Access Compliance Report

Public Rights-of-Way

(Curb Ramps)

Intersection ID: 10024219	Main Street: COVENTRY COURT LN	Cross Street: N/A	Location: NE
ADA ID: 63EC0205BE5A	Ramp Type: Perp	Initial Pass/Fail: Pass	Overall Compliance: No
Codes/Mitigation Info/Possible Solution		Field Measurements/Component Compliance	
Severity Score: 0.25

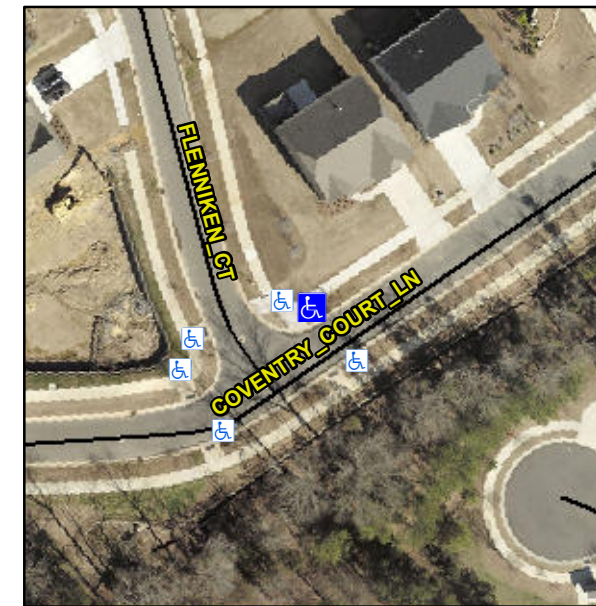
Not Found, R304.5.3

Compliance	Description	Data	Compliance	Description	Data
N/A	Ramp Length (in)	25.0	Yes	Ramp Slope (%)	5.7
Yes	Ramp Width (in)	48.0	No	Ramp XSlope (%)	4.1
N/A	Flare Type LT	Sloped	N/A	Flare Type RT	N/A
N/A	Flare Slope LT (%)	1.6	Yes	Flare Slope RT (%)	8.1
N/A	Flare Traversable LT?	Yes	N/A	Flare Traversable RT?	Yes
Yes	Landing Length (in)	71.5	Yes	DWS Provided?	Yes
Yes	Landing Width (in)	48.0	Yes	DWS Contrast?	Yes
Yes	Landing Slope (%)	1.2	Yes	DWS Length (in)	24.0
No	Landing X Slope (%)	4.5	Yes	DWS Full Width?	Yes
N/A	Landing Curb? (Y/N)	No	Yes	DWS Offset (in)	1.0
N/A	Shared Landing?	No			
Yes	Gutter Ponding?	No	Yes	Gutter Slope (%)	4.9
Yes	Gutter Lip Ht (in)	0.0	No	Gutter X Slope (%)	2.6
N/A	Painted X Walk1?	No	N/A	Painted X Walk2?	N/A
	X Walk 1 Direction	To SE		X Walk 2 Direction	N/A
N/A	X Walk 1 Width (in)	N/A	N/A	X Walk 2 Width (in)	N/A
	X Walk 1 Slope (%)	3.4		X Walk 2 Slope (%)	N/A
	X Walk 1 X Slope (%)	2.5		X Walk 2 X Slope (%)	N/A

**Remove & Replace Entire Ramp.
Remove & Replace Gutter.**
